### Technical changes to the exhaust manifold, new EGR pipe and heat shield ?

**Vehicle Manufacturer:** VW

**Vehicle:** T6 2.0 tdi

**Engine code:** CXHA, CXHB, DNAA

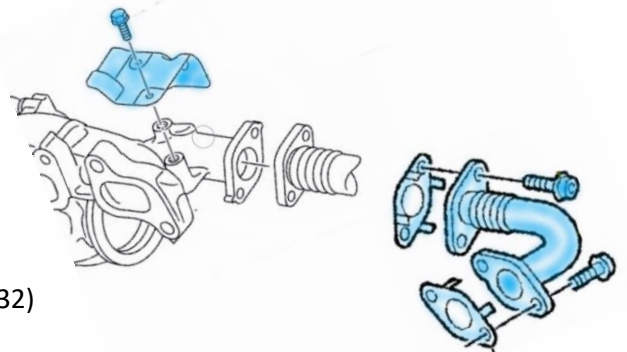
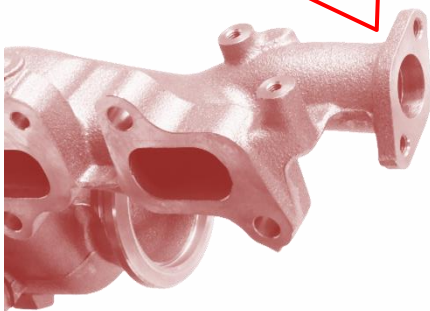
The vehicle manufacturer has made an extensive change to the exhaust manifold of the turbocharger at the flange of the EGR pipe. It is exclusively produced the new variant of the turbocharger.

Until 08.12.2018, the old version of the 04L253014L / 830323-xxxx turbocharger was installed in the vehicles. Production of this version has been terminated.

If the turbocharger has to be replaced, only the new variant 04L253014M / 873767-xxxx is available. The following instructions must be observed.

If the old version marked in red has to be replaced, the vehicle manufacturer requires the following components:

2x	106 884 02	screw M6x8	(D970096)
1x	03N 145 811 B	heatshield	(D950333)
2x	03L 131 547 P	gasket	(D950036)
2x	N 910 461 01	screw M8x22	(D970024)
2x	N 910 268 02	screw M8x20	(D970036)

1x	04L 131 521 BF	EGR-connecting pipe	(D950332)
----	----------------	---------------------	-----------
